Access Compliance Report Public Rights-of-Way (Curb Ramps)

Main Street: MAIN_ST Cross Street: SIENNA_PKWY Location: SW

ADA ID: RPRK211022123736 Ramp Type: Type 4 - Parallel Initial Pass/Fail: Fail Overall Compliance: No Severity Score: 30

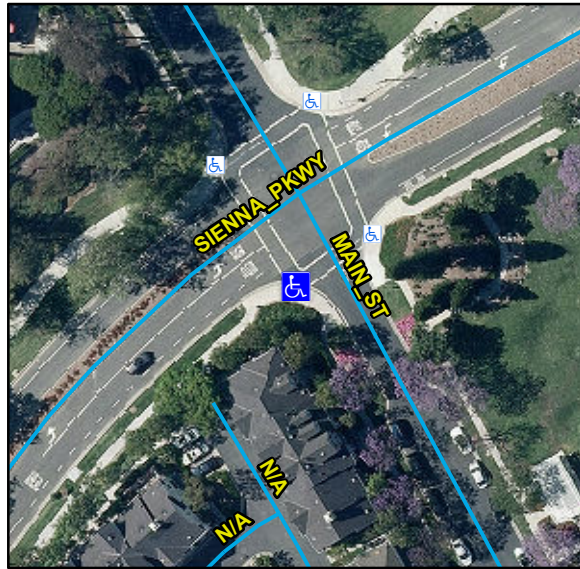
Compliance	Description	Data	Compliance	Description	Data
N/A	Ramp Length LT (in)	115	N/A	Ramp Length RT (in)	110
Yes	Ramp Width LT (in)	90	Yes	Ramp Width RT (in)	90
Yes	Ramp Run Slope LT (%)	1.3	Yes	Ramp Run Slope RT (%)	3.2
No	Ramp Cross Slope LT (%)	5.2	No	Ramp Cross Slope RT (%)	7.8
N/A	Landing Present	N/A	N/A	DWS Provided	N/A
N/A	Landing Length (in)	N/A	N/A	DWS Contrast	N/A
N/A	Landing Width (in)	N/A	N/A	DWS Length (in)	N/A
N/A	Landing Run Slope (%)	N/A	N/A	DWS Full Width	N/A
N/A	Landing Cross Slope (%)	N/A		DWS Offset Type	N/A
N/A	Landing Movement Obstructed?	N/A	N/A	DWS Offset Left (in)	N/A
	Landing Movement Type	N/A	N/A	DWS Offset Right (in)	N/A
N/A	Landing Shared	N/A			
N/A	Clear Space	Yes			
N/A	Clear Space To Crosswalk (in)	48			
N/A	Marked Crosswalk 1	Yes	N/A	Marked Crosswalk 2	Yes
	Crossing 1 Direction	E		Crossing 2 Direction	N
	Marked Crosswalk 1 Width (in)	90		Marked Crosswalk 2 Width (in)	90

Remove & Replace Curb Ramp With Two New Directional Ramps or Equivalent.
